# SAFETY RECALL NOTICE

## Re: Can-Am Spyder Coast-to-Coast Accessory Passenger Seat Does Not Activate Pillion Switch

# PAC BULLETIN SAFETY CAMPAIGN

No. **2016-4**

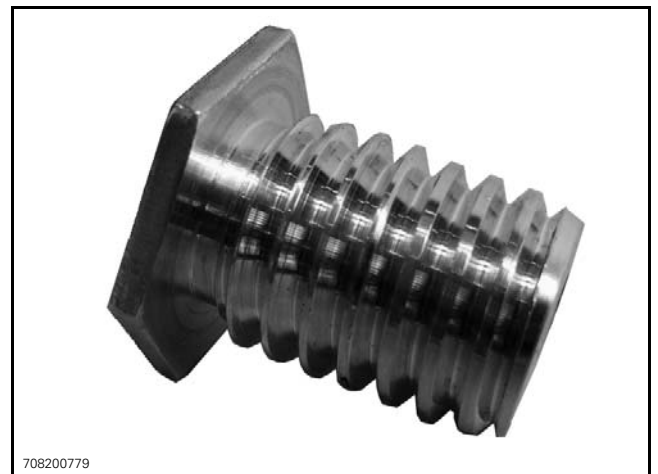
The pillion switch is not activated when a passenger is on the seat. This situation may results in a loss of control and possibly cause injuries or even death.

Install an activation stud under the passenger seat and test the pillion switch activation with B.U.D.S.

1. Remove the passenger seat.

2. Install the stud in the seat base.

3. Tighten to specification.

**NOTICE** Do not overtighten the plug. It would make the seat base to crack or to strip.

TIGHTENING TORQUE	
Activation stud	3.5 N•m ± 0.5 N•m (31 lbf•in ± 4 lbf•in)

4. Reinstall the passenger seat.

5. Test the switch activation with B.U.D.S. Refer to *PILLION RIDER (PASSENGER) SWITCH (PRS)* in *VEHICLE STABILITY SYSTEM (VSS)* subsection, in the appropriate shop manual.
